STAFF RECOMMENDATION 412 Rudolph Avenue October 19, 2016

Application: Demolition—outbuilding; New construction—detached accessory dwelling unit

Description of Project: Application is to demolish an existing outbuilding and construct a detached accessory dwelling unit (DADU) at the rear of the lot.

Figure 1. 412 Rudolph Avenue

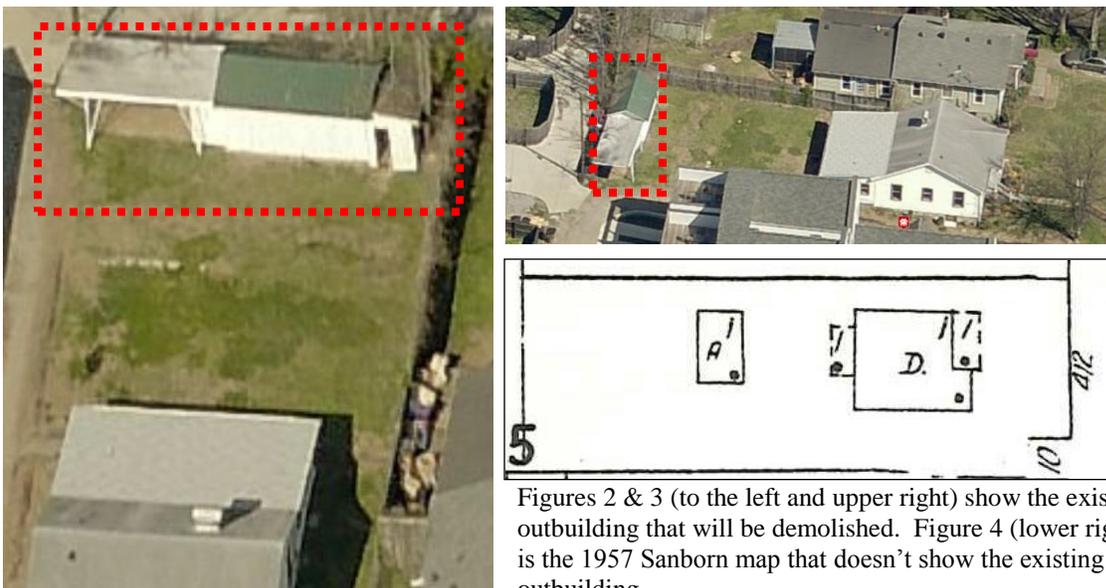
Background: 412 Rudolph Avenue is a c. 1930 frame house that contributes to the historic character of the Lockeland Springs-East End Neighborhood Conservation Zoning Overlay (Figure 1).

Site Plan

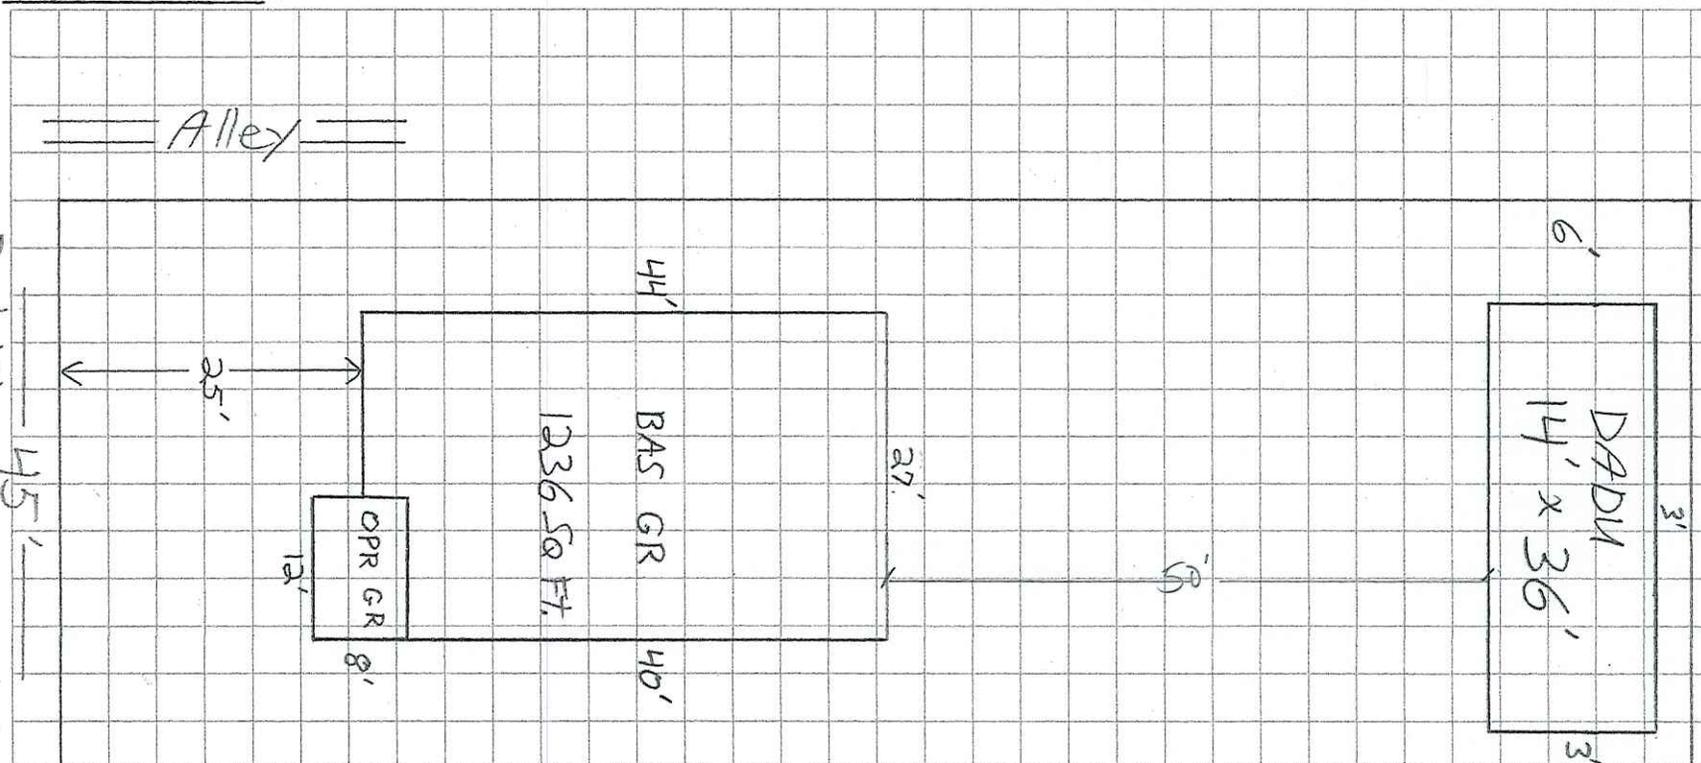
Setbacks: The proposed DADU meets all base zoning setbacks. It will be three feet (3') from the rear property line, three feet (3') from the right side property line, and six feet (6') from the left side property line. The outbuilding will not include a vehicular door.

Staff finds that the proposed setbacks are appropriate. Staff finds that the DADU meets Section II.B.3. of the design guidelines and 17.16.030.G. 4 of the ordinance.

MINIMUM	PROPOSED
Space between principal building and DADU/Garage	20'	40'
Rear setback	3'	3'
L side setback**	3'	6'
R side setback**	3'	3'
How is the building accessed?	From the alley or existing curb cut	From side alley

As mentioned under “Setbacks,” the DADU meets all base zoning setbacks. Staff finds that the DADU meets section II.B.8 of the design guidelines and 17.16.30.G. 4 of the ordinance.

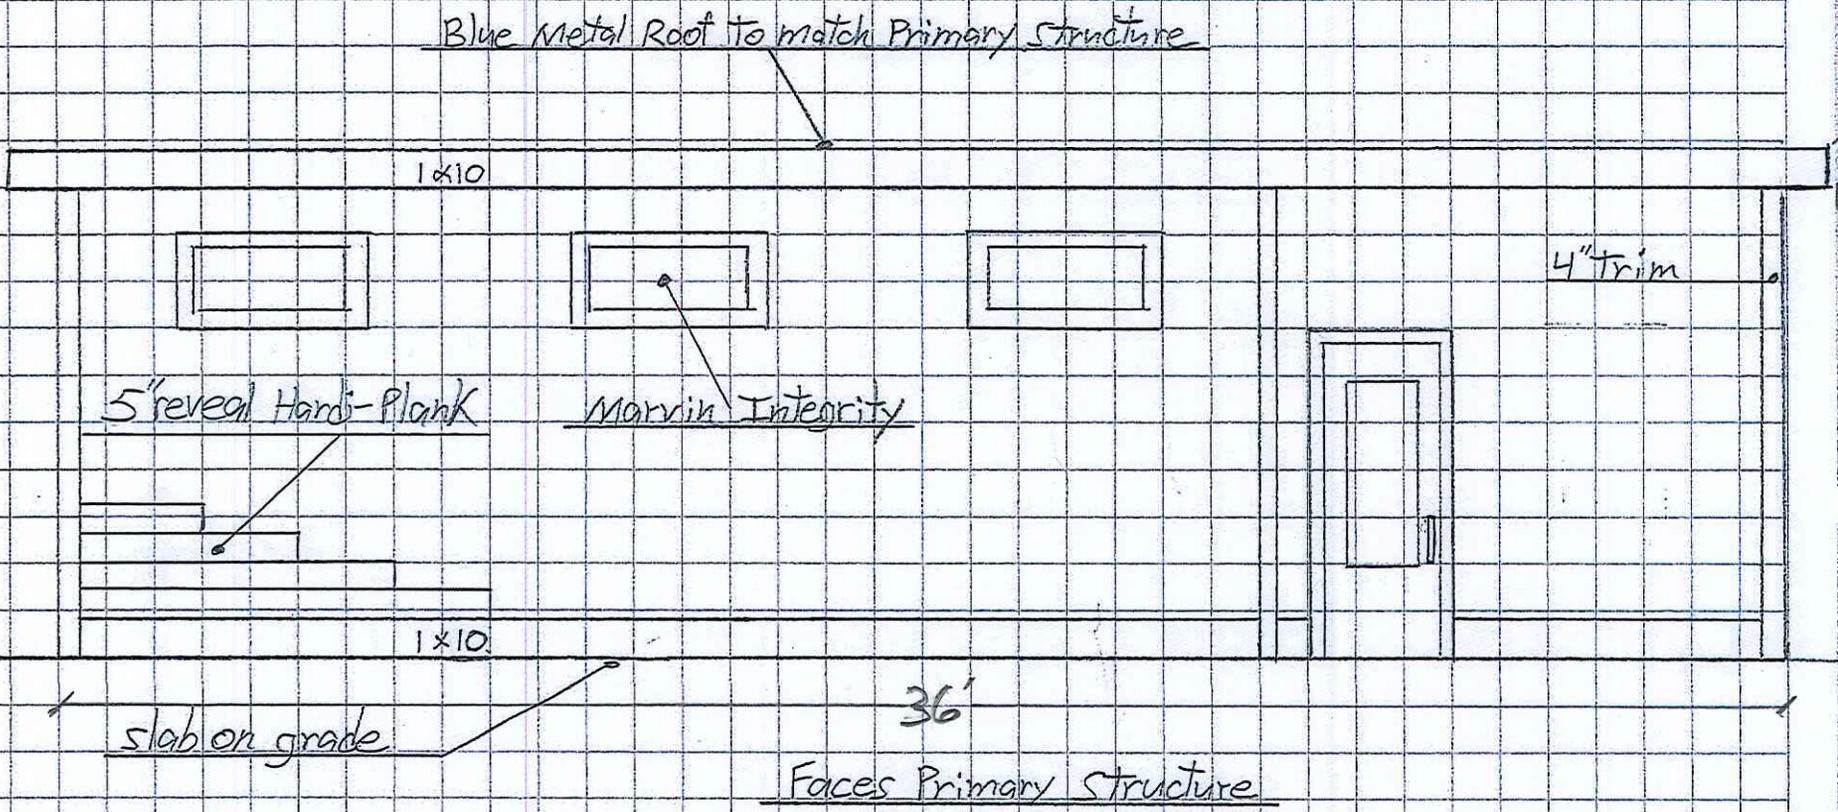
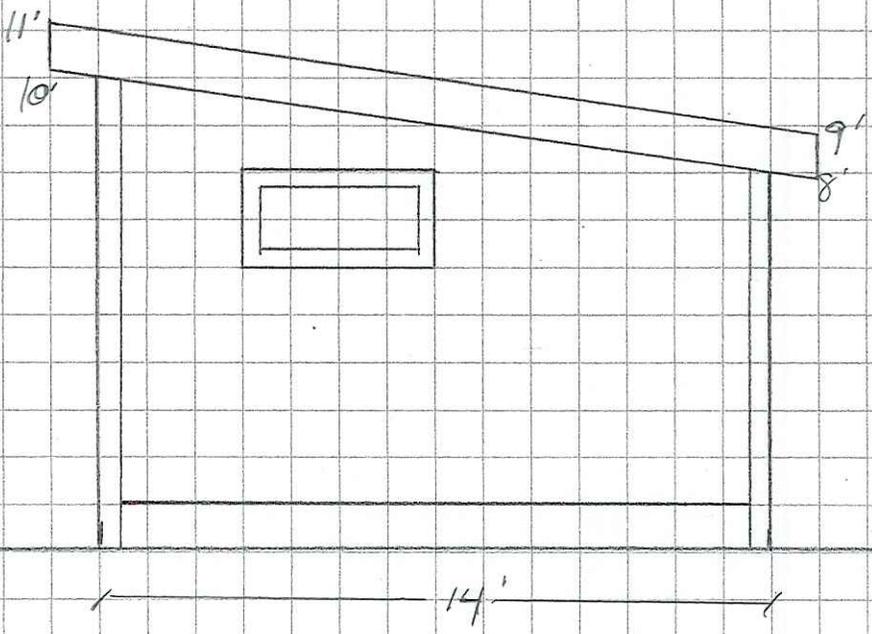
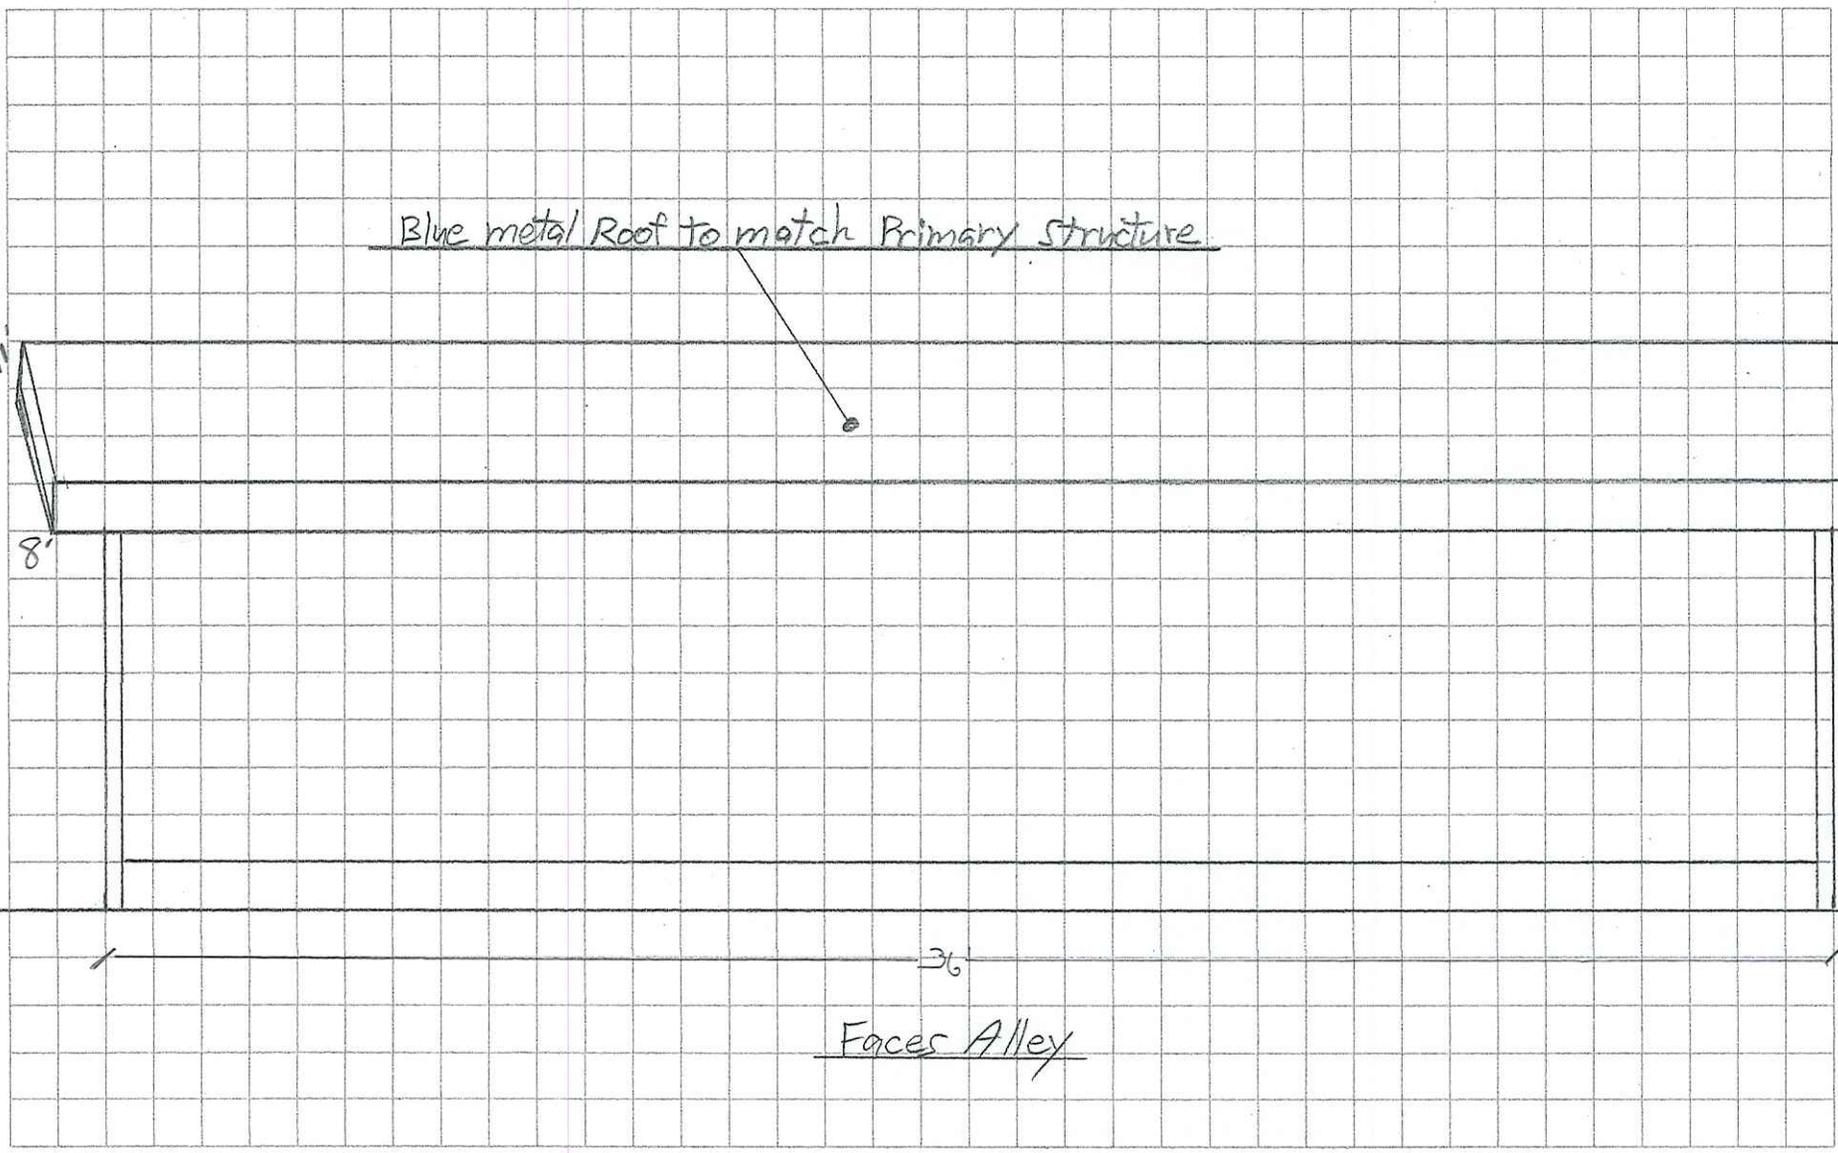
The applicant is proposing a one-story garage and DADU. A low-sloping shed roof like the one proposed for the DADU is not typical of the neighborhood for historic primary structures. However, staff finds it to be appropriate for an outbuilding at the rear of the lot. Outbuildings were traditionally utilitarian in design. In addition, the 2/12 shed form allows the height of the structure to remain minimal and to be a true one-story structure. Staff finds that the DADU meets Section II.B.8 of the design guidelines and section 17.16.030.G.8 of the DADU ordinance.

Design Standards: The accessory structure has a simple, utilitarian design that is appropriate for outbuildings. Its roof form, detailing, and form do not contrast greatly with the primary structure. The fenestration is of a more modern layout and is atypical of the neighborhood context, but is appropriate for an outbuilding. It is also in a minimally-visible location at the rear of the historic house. Staff finds that the DADU's design meets section II.B.8 of the design guidelines and Section 17.16.030.G.8 of the ordinance.

As mentioned under roof shape, the proposed roof form is a 2/12 shed. Staff finds the low-slope roof to be appropriate because it helps to keep the overall height of the one-story structure low. Staff finds that the DADU meets section II.B.8 of the design guidelines and sections 17.16.30.G.5, 8 and 9 of the DADU ordinance.

Existing conditions (height of historic portion of the home to be measured from finished floor)	Potential maximums (heights to be measured from grade)	Proposed (should be the same or less than the lesser number to the right)
Ridge Height	19'	25'	11'
Eave Height	10'	1 story 10' or 2 story 17'	10'

With the staff's final approval of the doors, staff finds that the known materials meet Section II.B.8. of the design guidelines.

1. Staff approve the final details, dimensions and materials of the pedestrian doors prior to purchase and installation; and
2. Staff receive a copy of the filed restrictive covenant for the detached accessory dwelling unit prior to issuance of a permit.
